Building Permit Application

Permit No.: B19001587

Subject: Project name WALSMAN RESIDENCE
Project site address 1834 ~~WALSMAN RD~~ Long Corner Rd
Permit # B19001587 SDP # _____
Other information pertinent to this project re-submit plans

REMODELING OF THE RESIDENCE OF
 DAN AND DIONNE WALSMAN
 1834 LONG CORNER RD. MT. AIRY, MD

PARTIAL BASEMENT FLOOR PLAN

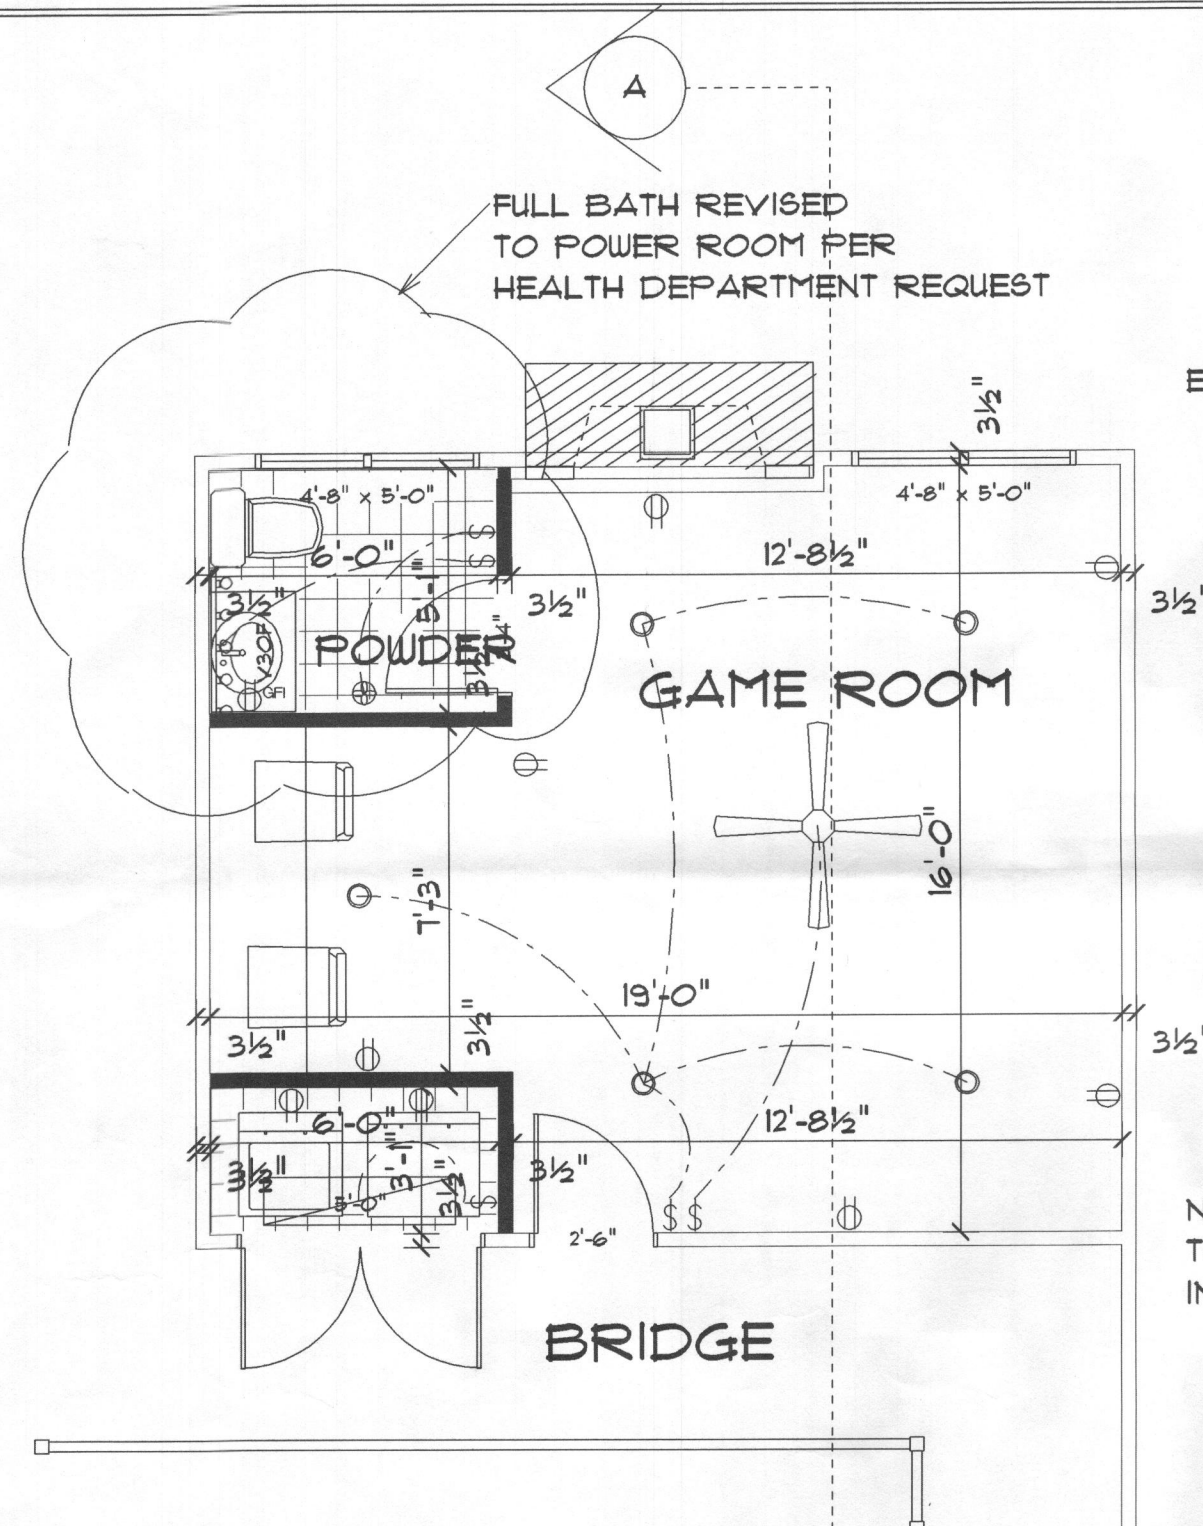
1834 Long Corner Rd.
 B 19001587
 Home Office, does not have direct access to existing Bath
 Add Home Office w/ utility space
 Add plus enclosed storage
 6/19/2019
 Approved Septic System Plan
 Howard County Health Department

REVISED
 Date: 6-17-19
 Comments: Revised floor plan to finish basement
 Rooms to include office, + storage room

SECOND FLOOR FRAMING PLAN
SCALE: 1/4" = 1'-0"

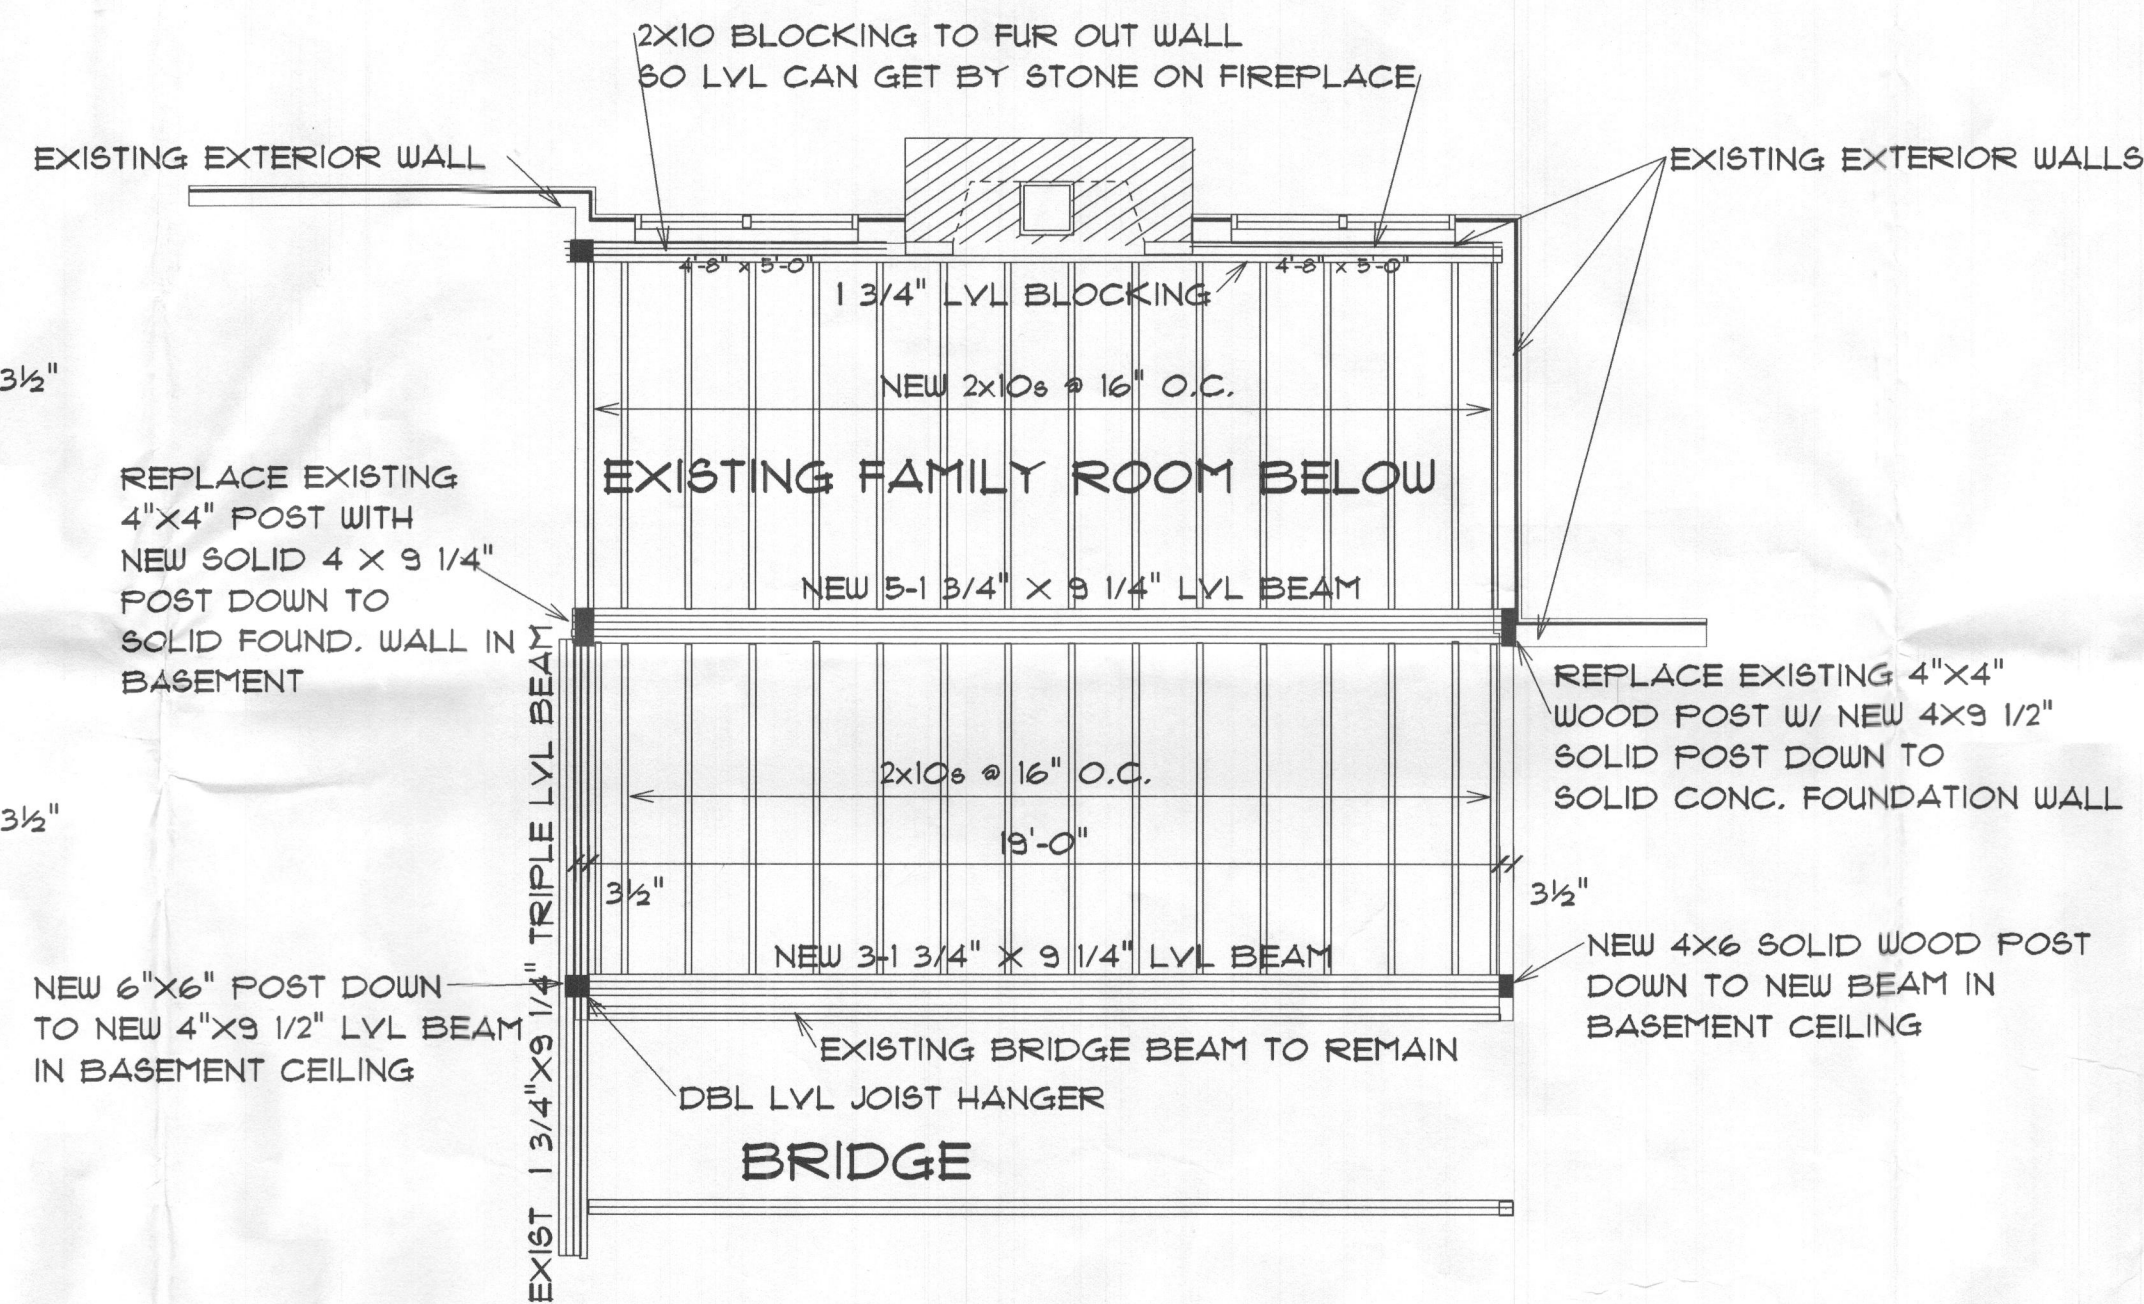
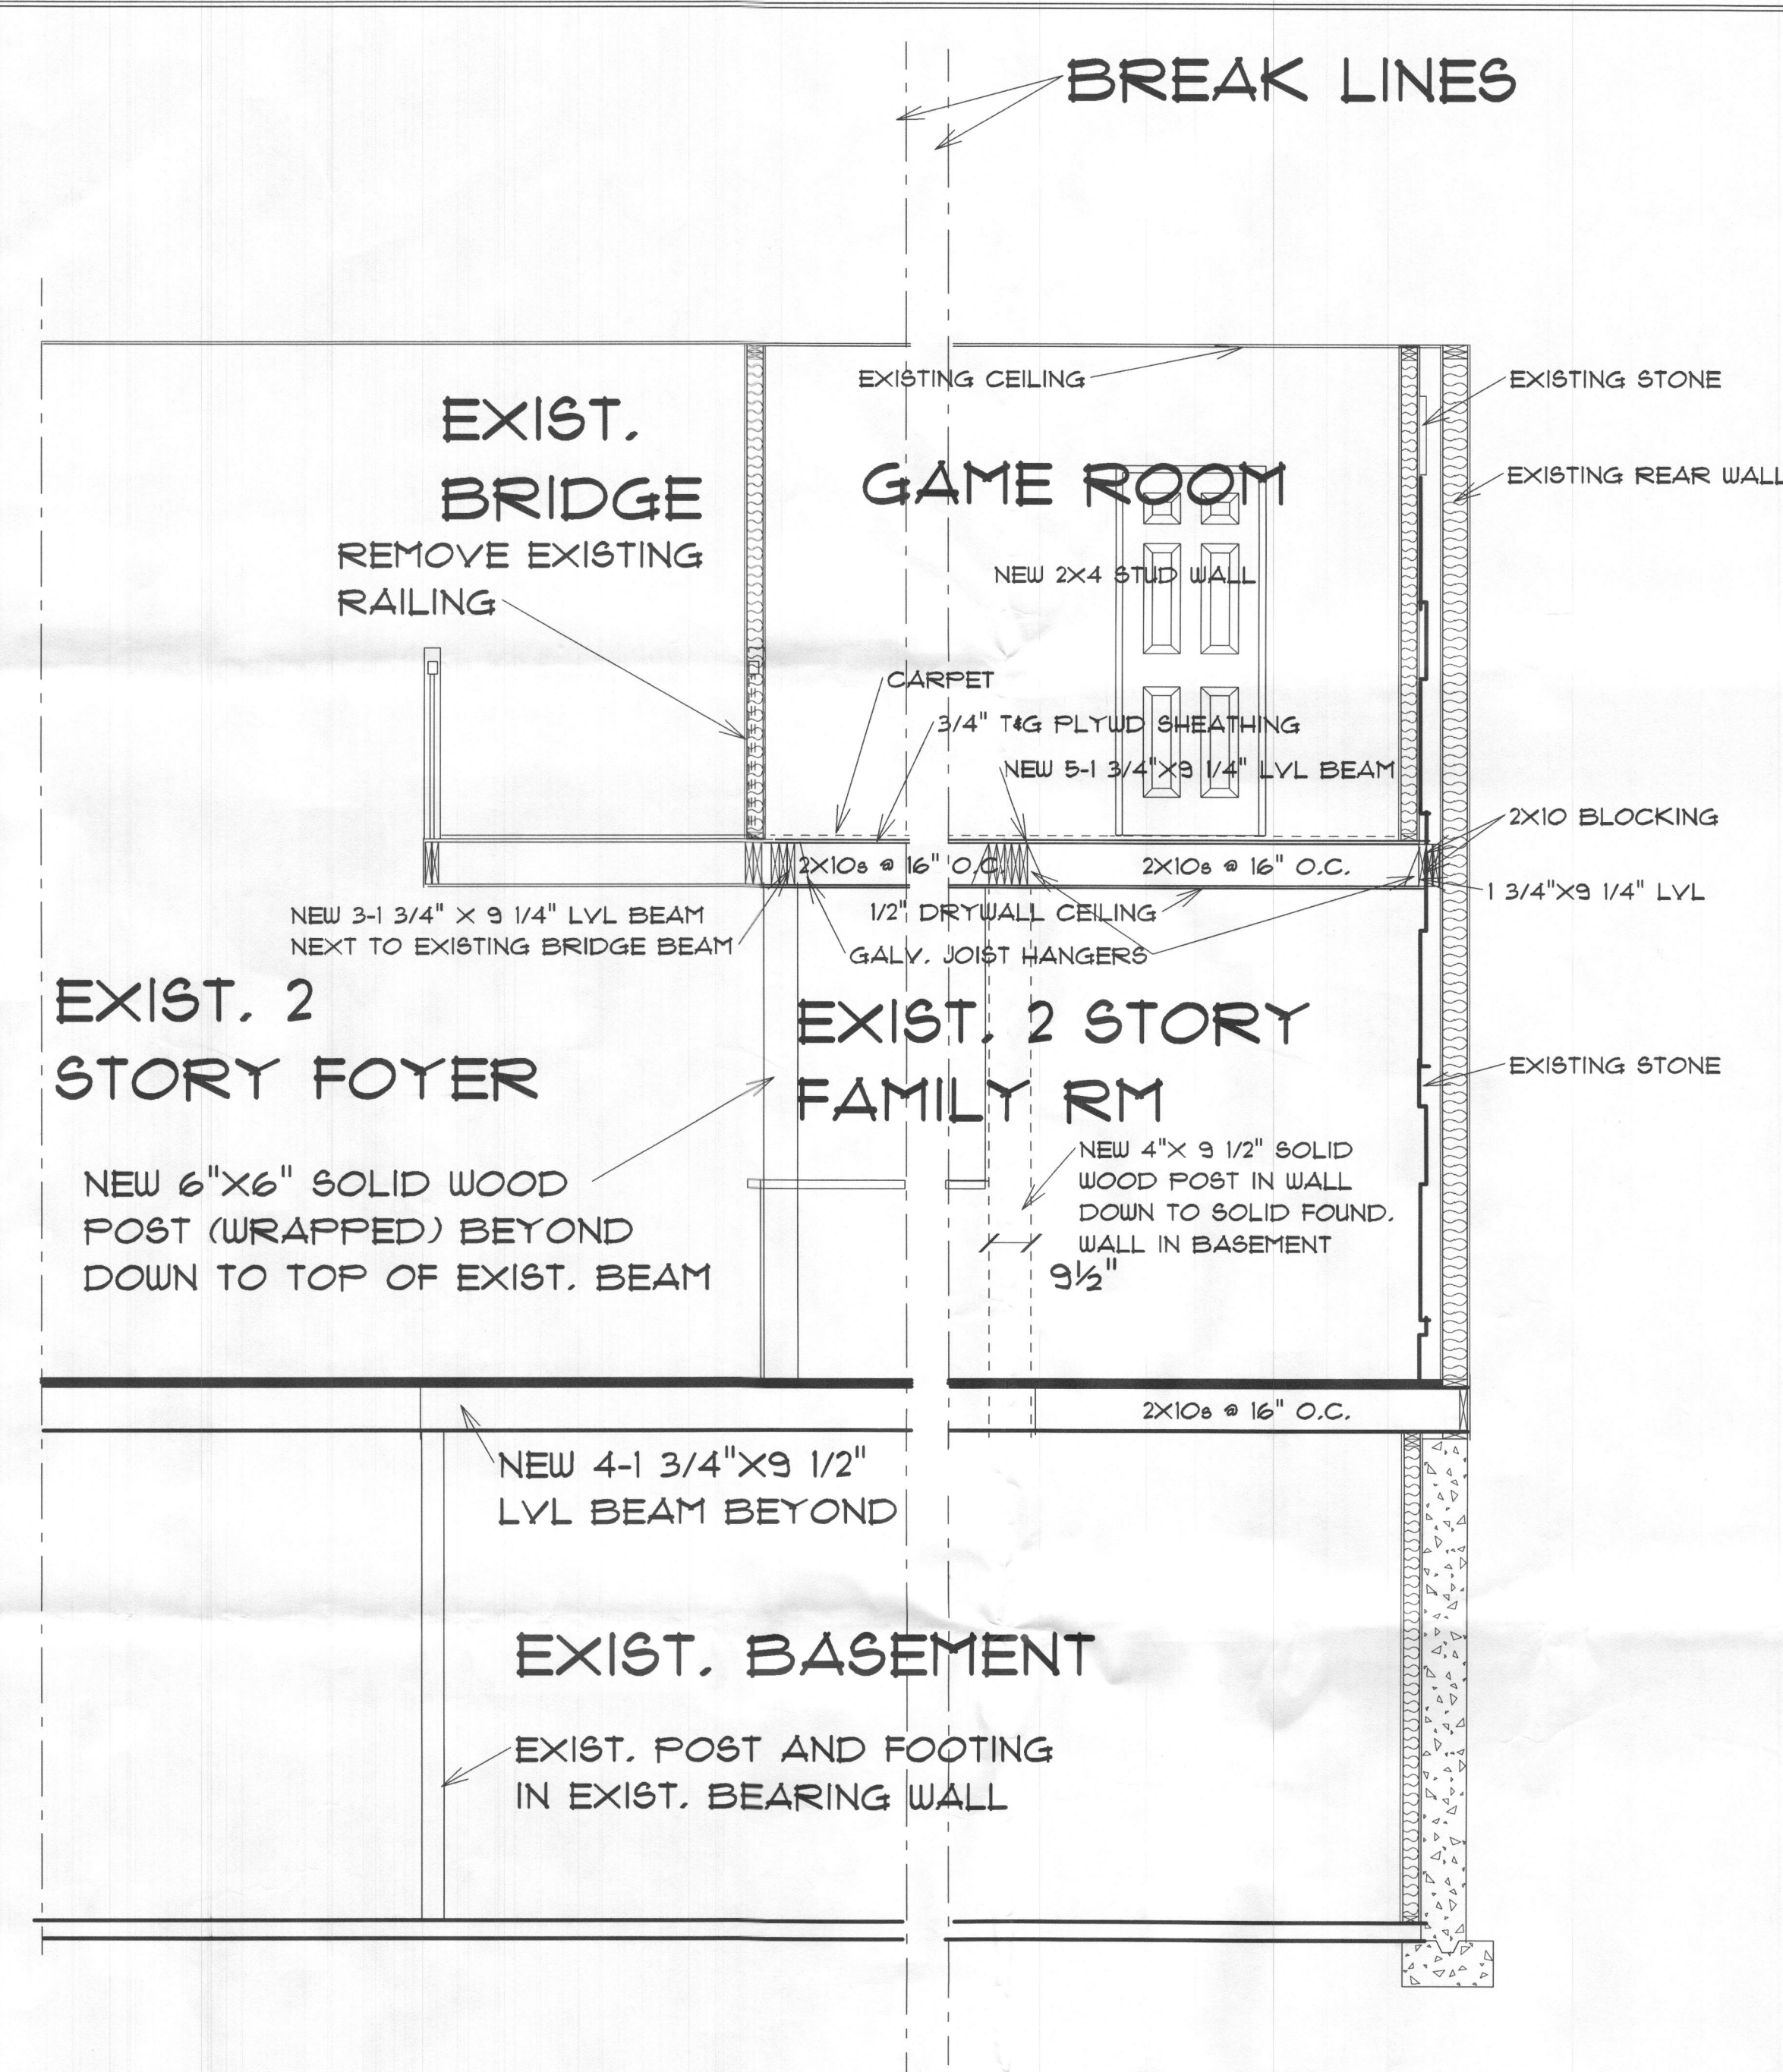
At your request, I meet with you earlier today and inspected and discussed the planned addition of living space over the open family room. The support beams seem to be the major problem with the existing being only 9.25" dimension. I recommend adding two beams over the space for the 19 foot dimension, one in the middle will be a five ply 9.5" microlam and the other next to the walkway will be a triple 9.25" microlam. These will bear on the foundation walls below for the first and on columns to the beams in the basement that are to be increased or added to make 4 ply 9.25" microlam that span the 14 feet from foundation to steel beam. The second beam will also need a column at the kitchen down to the basement beam. I am pleased to certify these beam as being proper in this case. I hope this letter meets your needs in this matter, but if there are any questions on this or other projects please contact my office.
